TONIGHT'S AGENDA

CITY COUNCIL MEETING - MAY 14, 2019
COMMUNITY CENTER & POOL DESIGN

KITCHEN DESIGN

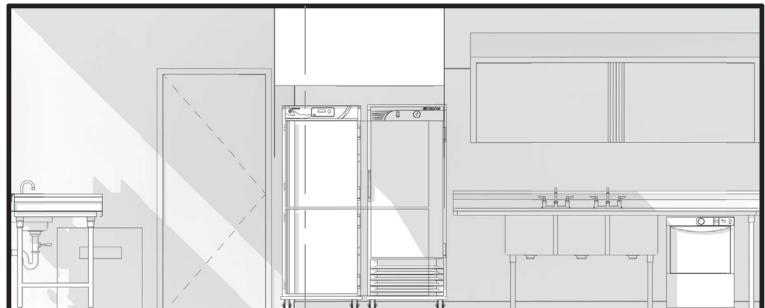
Comments from Steering Committee (5-6-19)

1- smaller range 5- show trash/ recyle

2- more counters 6- remove hot/cold storage

3- no dishwasher 7- open shelves

4- shorten depth of serving counter
